NUMBER: 25-003-20

Evaporative Emission Control System (EVAP) Purge Line Kinked

2020	(LA)	Dodge Challenger
2020	(LD)	Dodge Charger
2020	(LX)	Chrysler 300

**Fig. 2
Purge Line Routing**

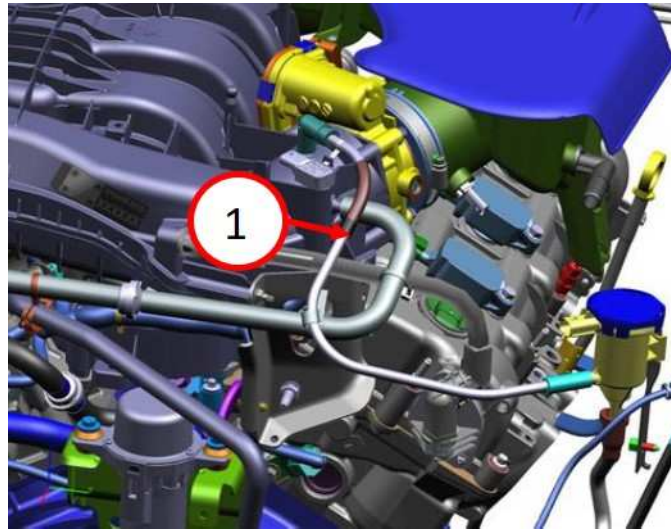
2. Install the new purge valve assembly. Re-route purge line behind brake boost tube (Fig. 2) .

NOTE: Remove the original clip that held the purge line to the brake booster line and discard.

**Fig. 3
Correct EVAP Purge Line Elbow**

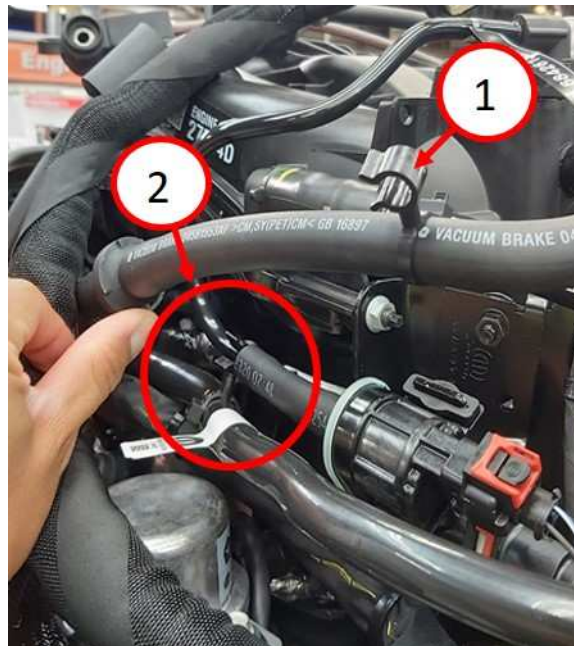
3. Remove clip from brake boost tube (Fig. 3) .
